51970-01893 Version 6

Recall: Driver's Airbag Inflator May Produce Excessive Pressure After Long-Term Exposure to High Absolute Humidity

Supersedes 14-029, dated April 14, 2015, to revise the information highlighted in **yellow**

04770-S5A-305

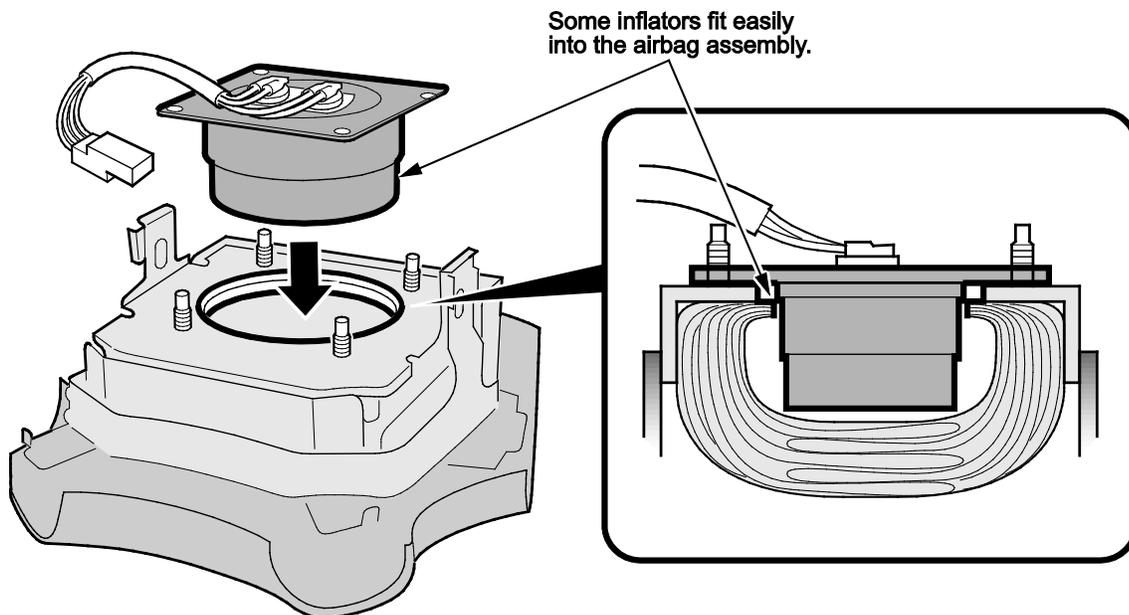
New and different inflators are available. Refer to step 9 of REPAIR PROCEDURE for new installation procedure and all applicable inflator part numbers.

NOTE: Step 9 under REPAIR PROCEDURE was changed to include installation procedures for all applicable inflator part numbers.

Refer to **Driver's Inflator Type 1** in the video.

- Insert the inflator into the opening.

NOTE: Make sure the inflator wires are positioned toward the bottom of the airbag. If you install the inflator incorrectly, you may not be able to reconnect the SRS airbag harness.
